**ADDENDUM #2**

REQUEST FOR QUOTATIONS (RFQ) NO.: 1220-040-2019-098  
TITLE: SUPPLY, DELIVERY AND INSTALLATION OF HVAC  
REPLACEMENT – SURREY ARTS CENTRE  
ADDENDUM ISSUE DATE: December 5, 2019  
CLOSING DATE: prefer to receive Quotations on or before:  
December 12, 2019

**2. AHU-2 REVISION**

M-5

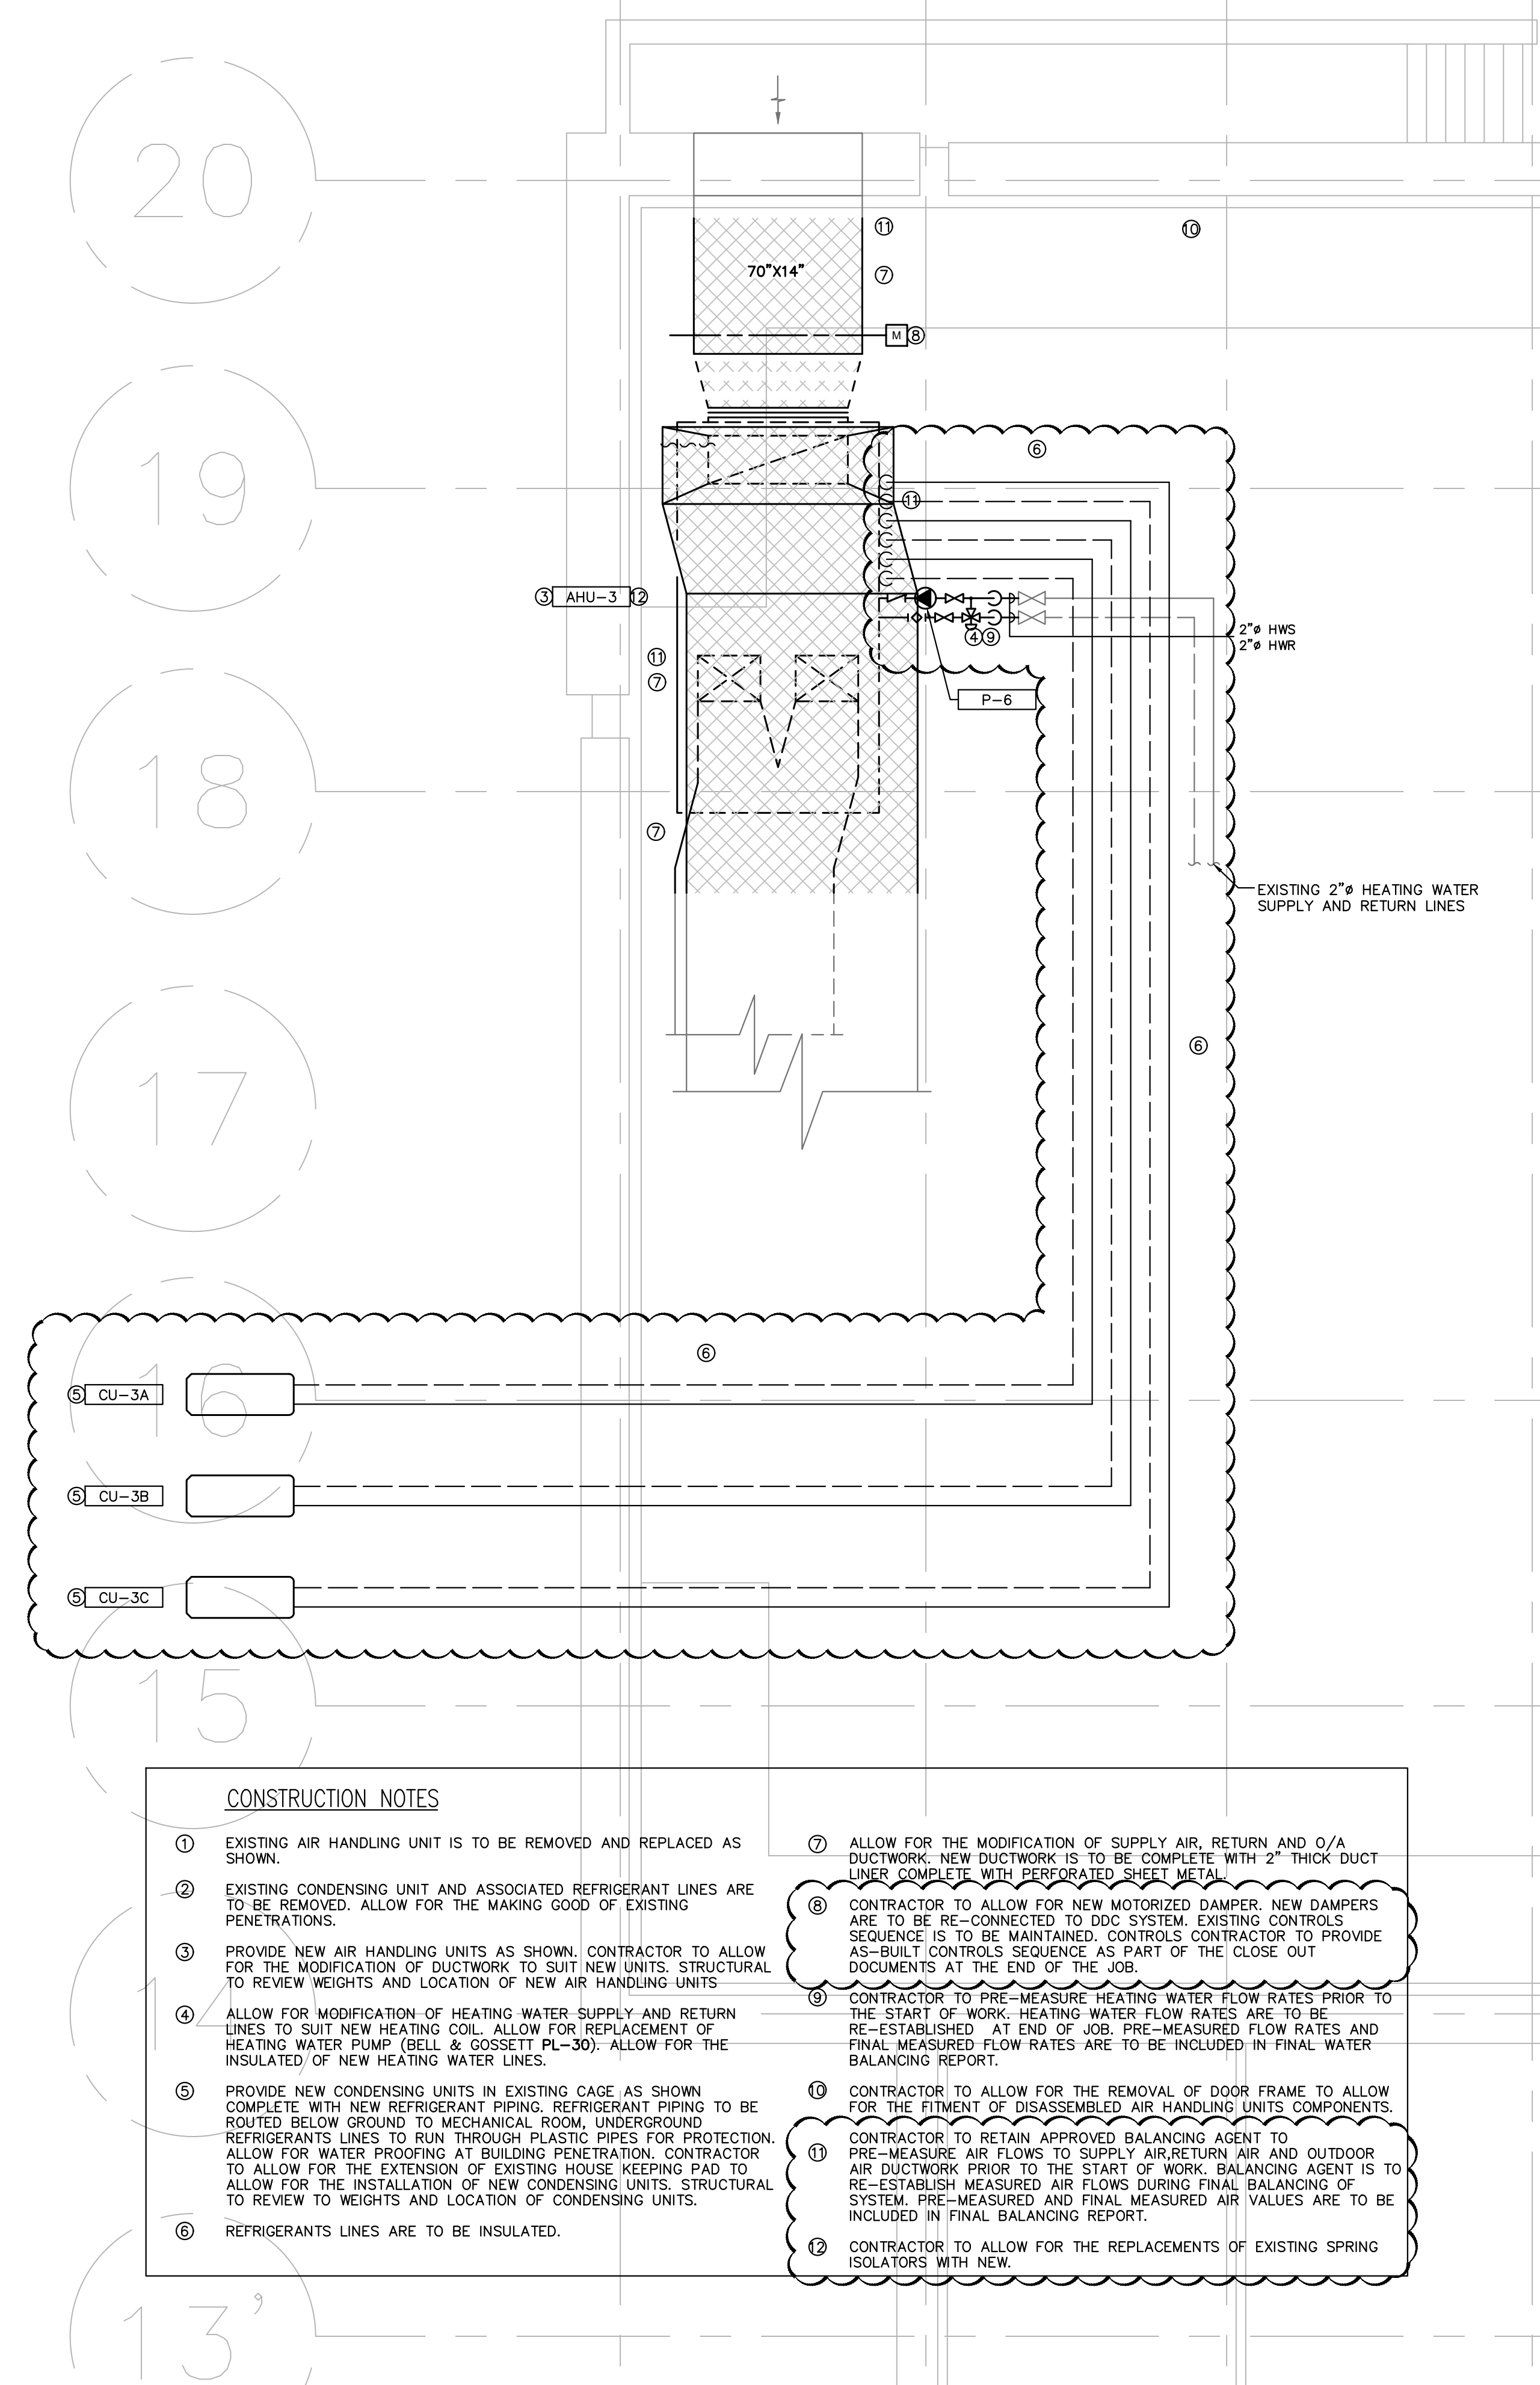
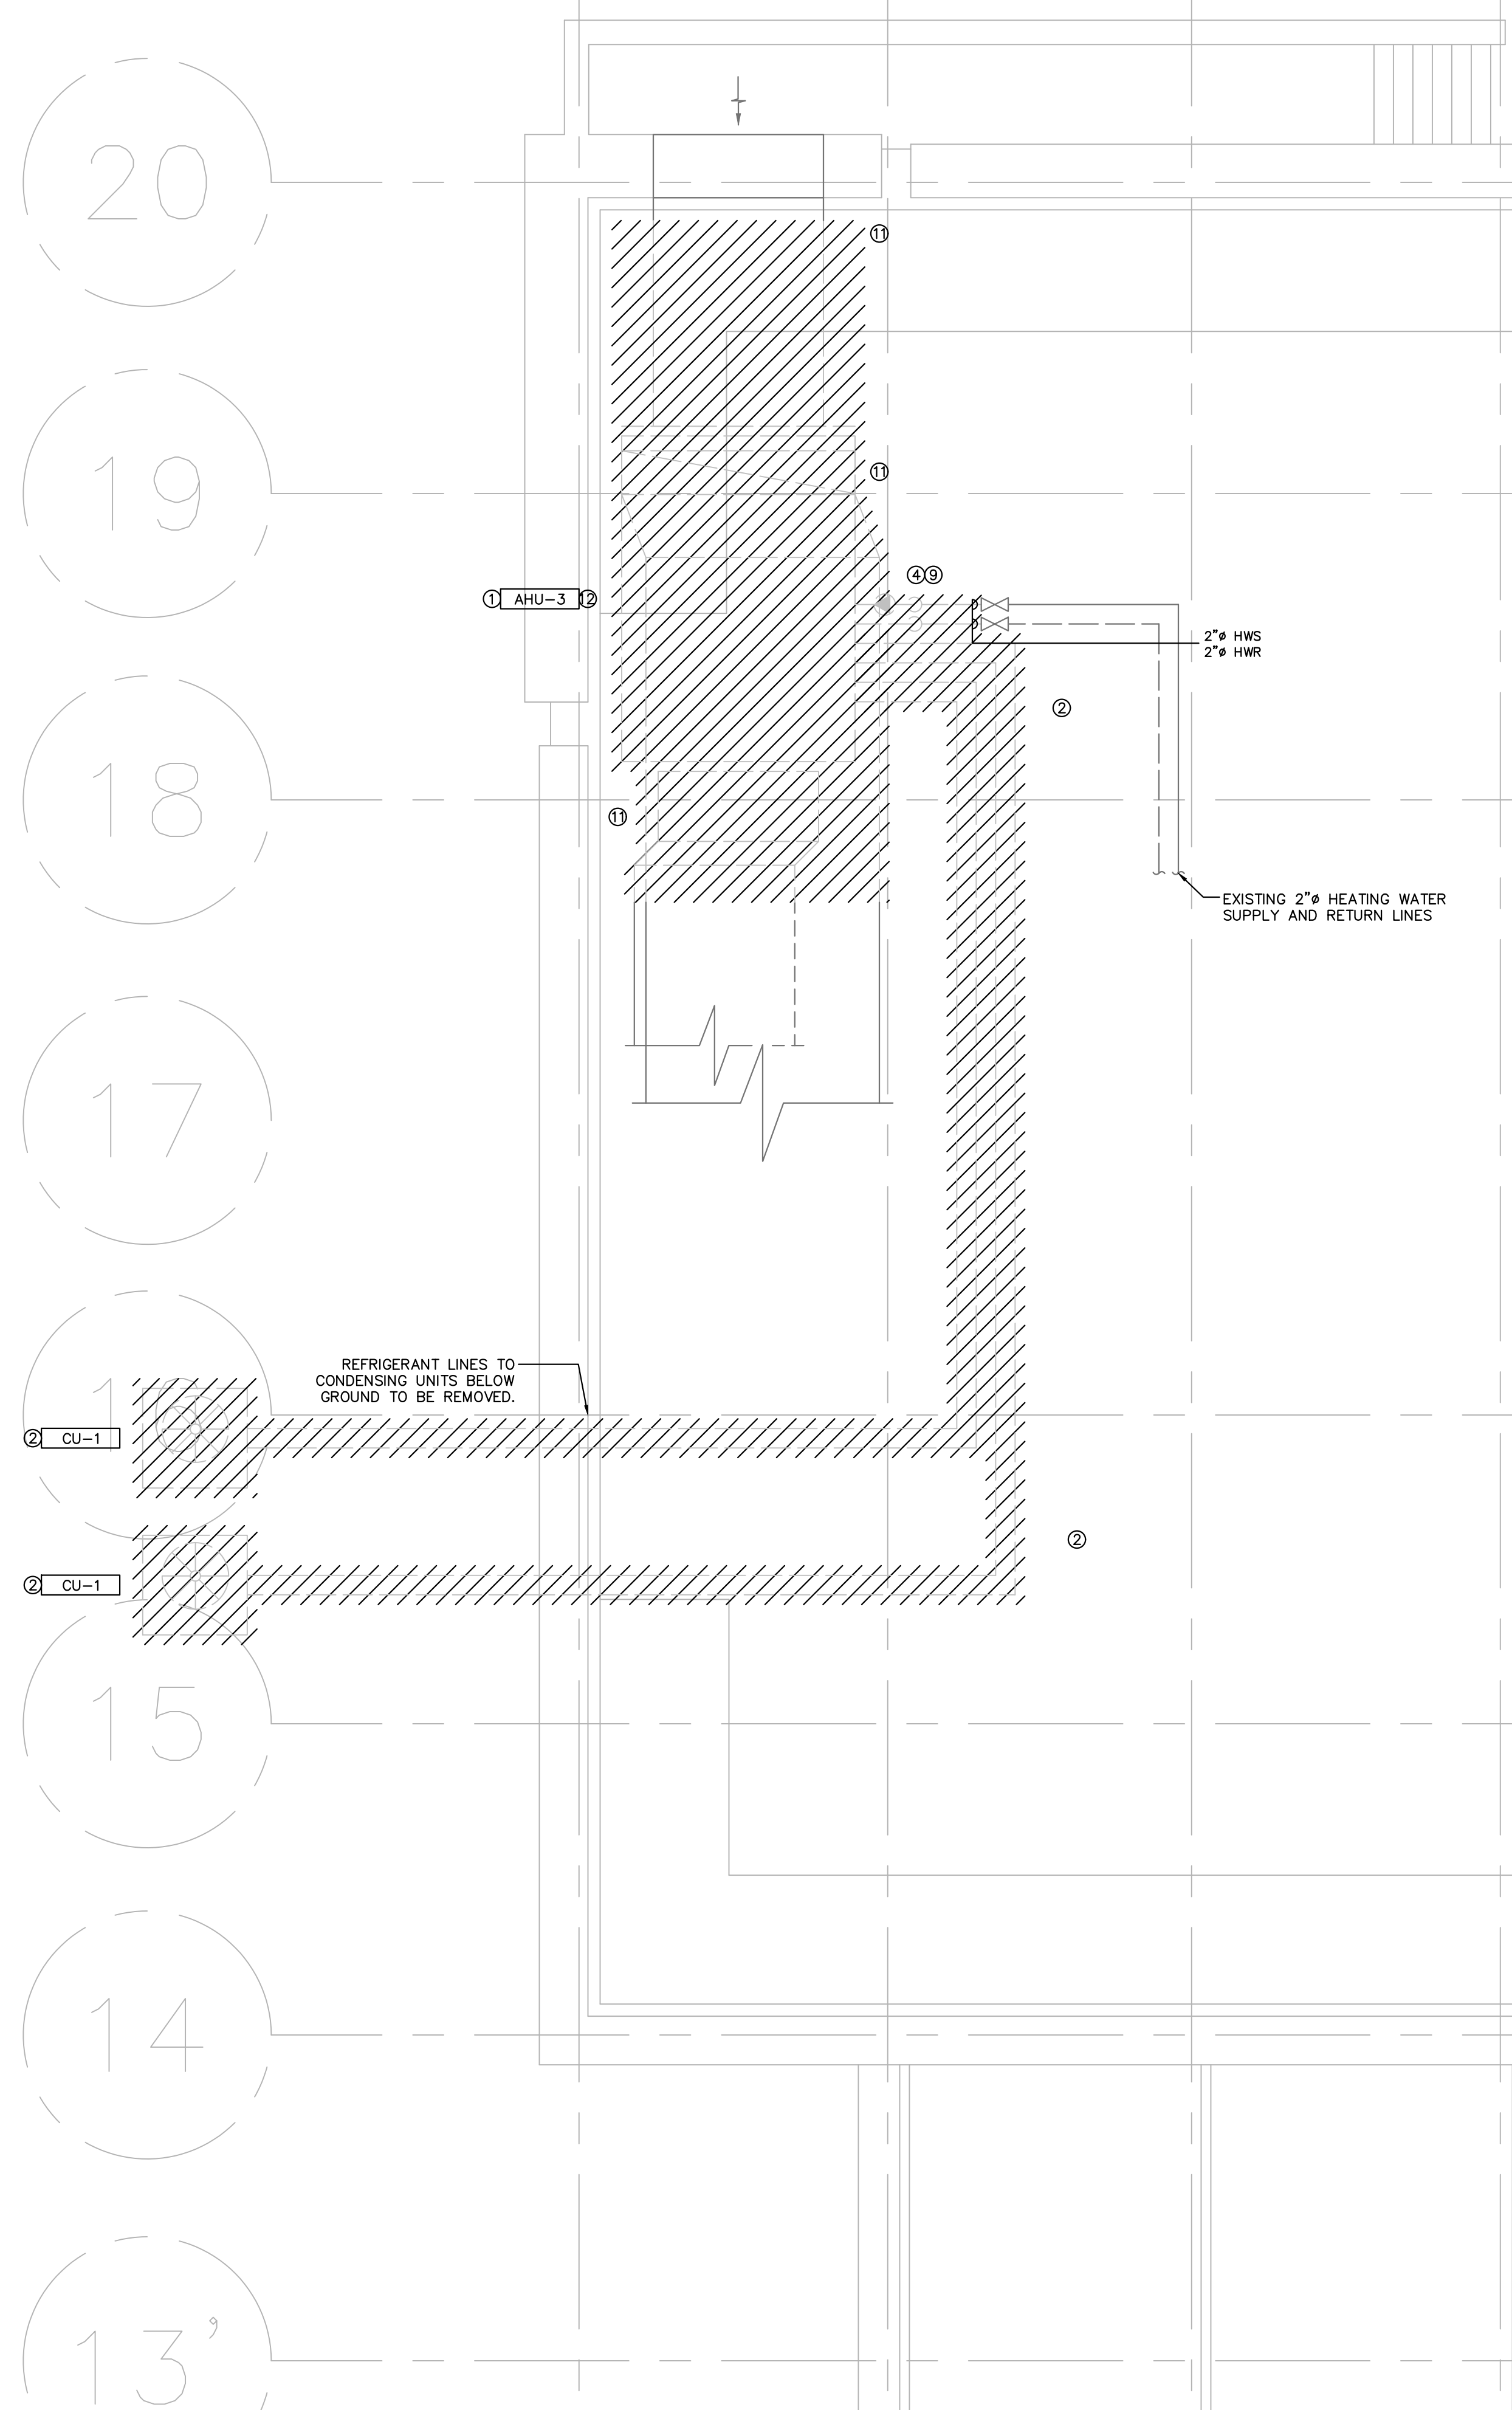
- 4.1 AHU-3 is to be provided three 5 ton outdoor units in lieu of two 7.5 ton units. New outdoor units are to be installed in existing cage in lieu of the roof, allow for the extension of existing house keeping pad to suit new outdoor unit installation
- 4.2 New refrigerant lines are to be routed below ground to the mechanical room. Underground refrigerant lines are to be routed through plastic pipes for protection
- 4.3 Allow for water proofing at the refrigerant line's penetration into the building.
- 4.4 AHU-1 is to be provided a cooling coil complete with 3 evenly sized circuits.
- 4.5 Refer to the attached drawings.

- 5 PROVIDE NEW CONDENSING UNITS IN EXISTING CAGE AS SHOWN COMPLETE WITH NEW REFRIGERANT PIPING. REFRIGERANT PIPING TO BE ROUTED BELOW GROUND TO MECHANICAL ROOM, UNDERGROUND REFRIGERANTS LINES TO RUN THROUGH PLASTIC PIPES FOR PROTECTION. ALLOW FOR WATER PROOFING AT BUILDING PENETRATION. CONTRACTOR TO ALLOW FOR THE EXTENSION OF EXISTING HOUSE KEEPING PAD TO ALLOW FOR THE INSTALLATION OF NEW CONDENSING UNITS. STRUCTURAL TO REVIEW TO WEIGHTS AND LOCATION OF CONDENSING UNITS.
